MEMORANDUM

TO: Christopher Ketchen, Town Manager, Lenox, MA

FROM: Weston & Sampson

SUBJECT: Weston & Sampson Review of Rest of River On-Site and Off-Site Transportation and Disposal Plan

FIGURE 2
HOUSATONIC RIVER,
PRIMARY STUDY AREA
(REACHES 5 AND 6) AND
REACHES 7 AND 8

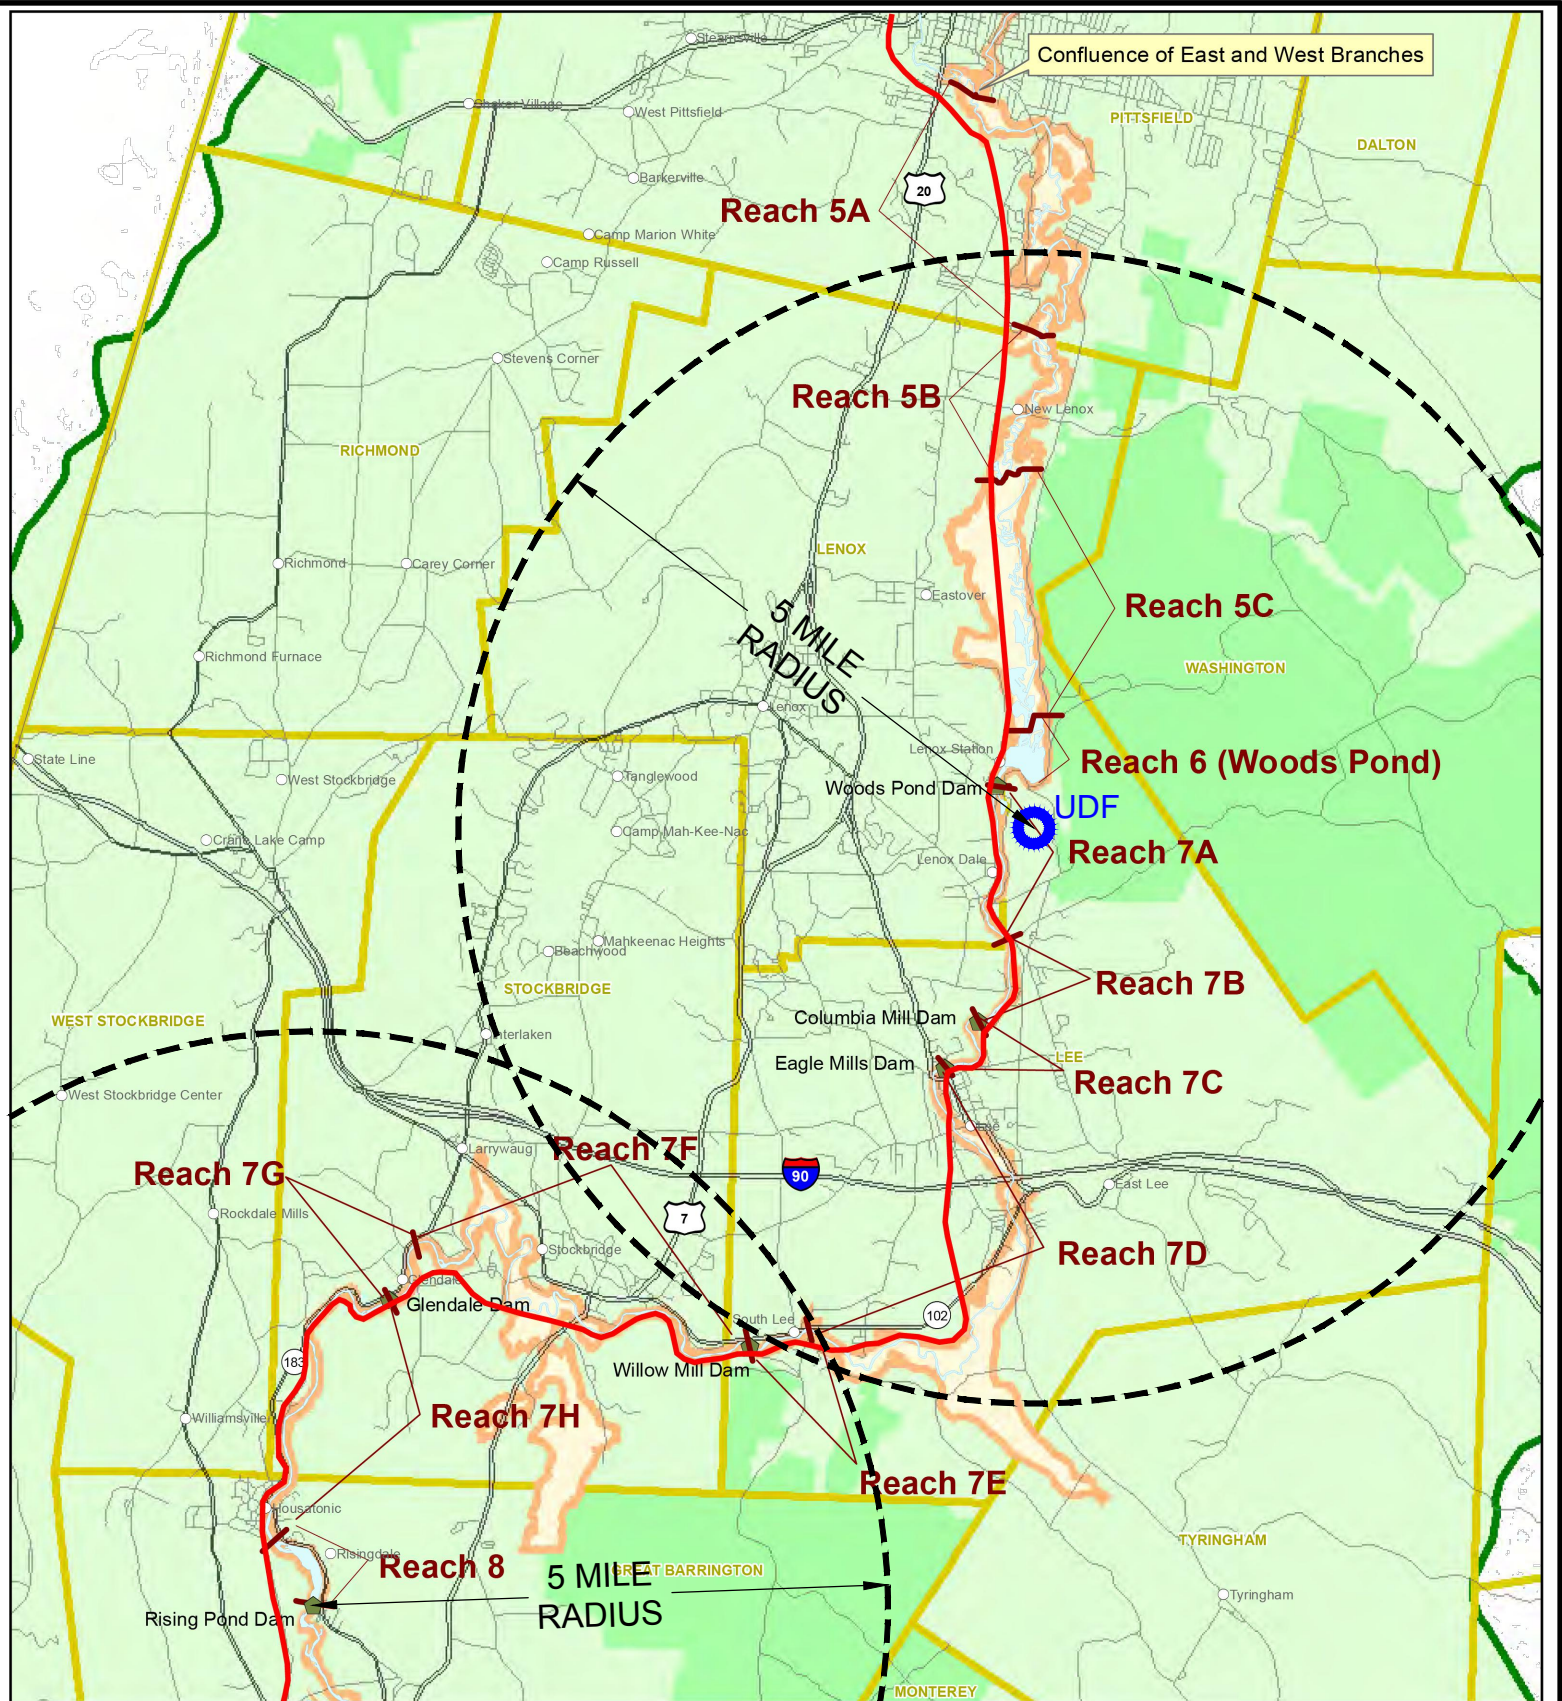
As seen on Table 2-1, nearly 65% of the total volume of planned removal materials will be from RUs 5C and 6. These RUs are located immediately to the north of the UDF (see the attached modified Figure 2 from the T&D Report) and there is mention in the report that hydraulic dredging will be considered for use and employed, if feasible, in these RUs. Table 3-1 in the T&D Report indicates that an estimated total of 590,000 CY will be conveyed by hydraulic conveyance, if feasible. This represents approximately 88% of the total volume to be removed from these two RUs and create a potential for a large reduction in trucks used to move dredged sediments.

Looking at the modified Figure 2, most of the RUs along the southern section of the Housatonic River dredging project are within five miles of this rail siding. It is requested that GE do further evaluations of hydraulic dredging and conveyance of dredged materials to this location for staging, processing, and eventual rail transport to the UDF. Again, this would greatly decrease the need for off-road and on-road trucking of dredged materials and decrease the need for construction of staging areas and haul roads. There are other sidings along the Housatonic Railroad that could be used for the temporary storage of rail cars holding dewatered and treated sediments (see attached photographs).
